Form 3160-5  
(June 2019)UNITED STATES  
DEPARTMENT OF THE INTERIOR  
BUREAU OF LAND MANAGEMENTFORM APPROVED  
OMB No. 1004-0137  
Expires: October 31, 2021**SUNDRY NOTICES AND REPORTS ON WELLS**  
**Do not use this form for proposals to drill or to re-enter an abandoned well. Use Form 3160-3 (APD) for such proposals.**5. Lease Serial No.  
NMSF078773  
6. If Indian, Allottee or Tribe Name**SUBMIT IN TRIPLICATE - Other instructions on page 2**

LOGOS Operating request a change in plans for the following:

Company: Logos Operating LLC  
Project: Rio Arriba, NM NAD83  
Site: Rosa Unit 31  
Well: Rosa Unit #740H  
Wellbore: OH  
Design: Plan #4

## LOGOS Operating, LLC Operations Plan

## WELL LOCATION AND ACREAGE DEDICATION PLAT

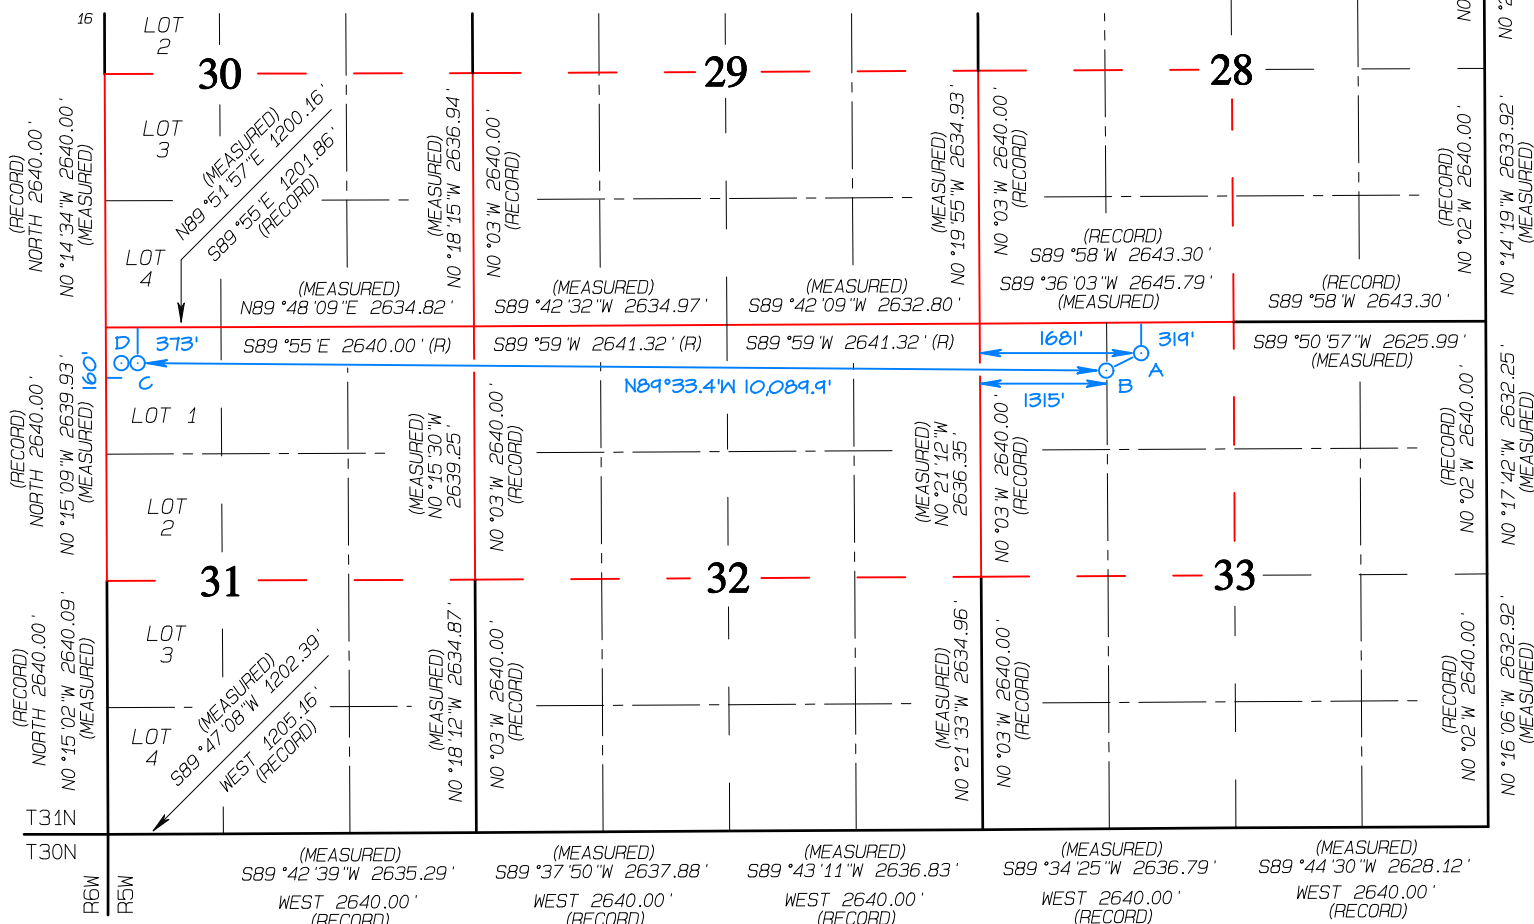
Original bottom-hole location from 559' FNL & 660' FWL to new **bottom-hole location 371' FNL & 160' FWL**Original TD @ 17,709' MD 7,132' TVD to new **TD @ 17,927' MD 7,067' TVD.**

UL or lot no.	Section	Township	Range	Lot Idn	Feet from the	North/South line	Feet from the	East/West line	County
C	31	31N	5W	1	371	NORTH	160	WEST	RIO ARriba

END-OF-LATERAL (D) 371' FNL 160' FWL  
SEC 31, T31N, R5W  
LAT: 36.862331°N  
LONG: 107.406638°W  
DATUM: NAD1927

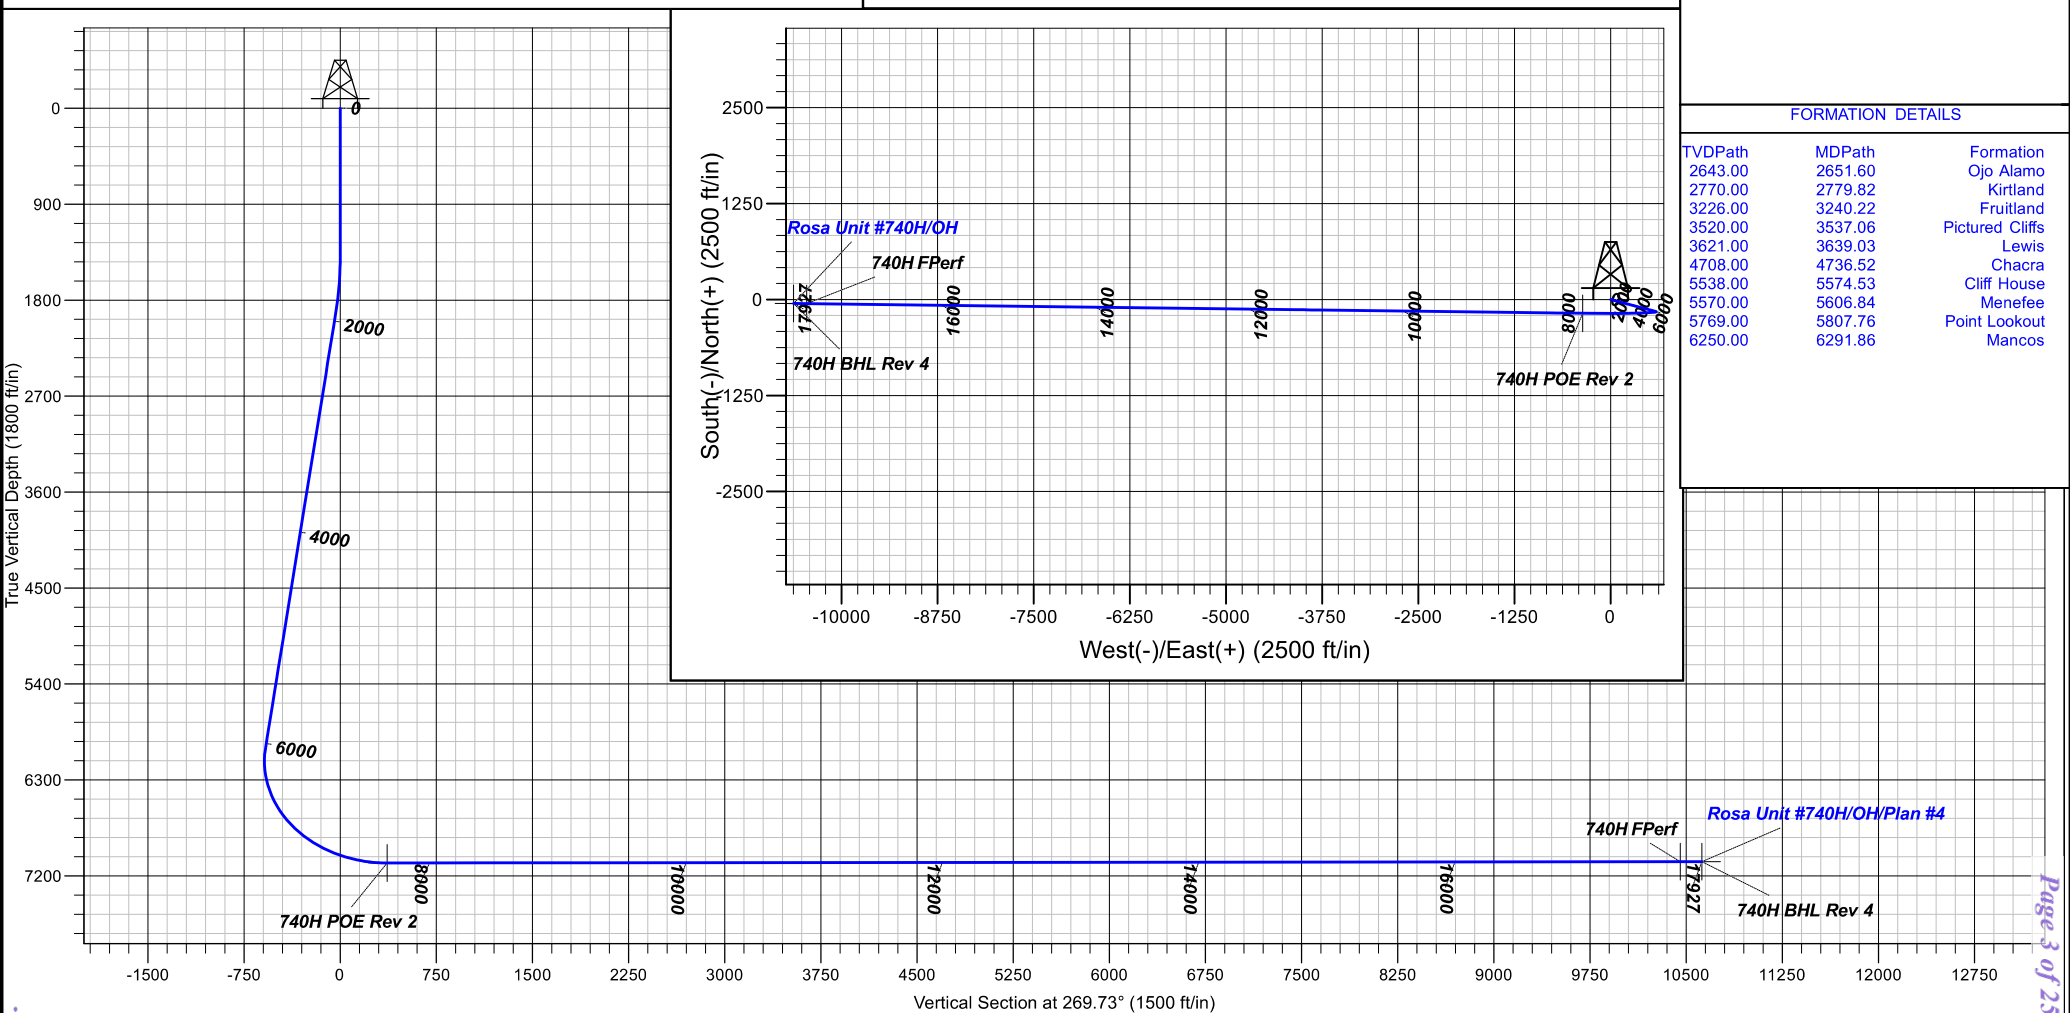
Original KOP @ 6,574' MD 6,515' TVD to new **KOP @ 6,038' MD 5,997' TVD**Original Landing point @ 7,575 MD 7,152' TVD to new **Landing point @ 7,667' MD 7,079' TVD**Original 7" casing Intermediate @ 6474' MD to **9.625" Intermediate casing, 6367' MD 6281' TVD**Original 4.5" casing Production Liner @ 17,709' MD to **5.5" Production casing, 17,927' MD 7,067' TVD**
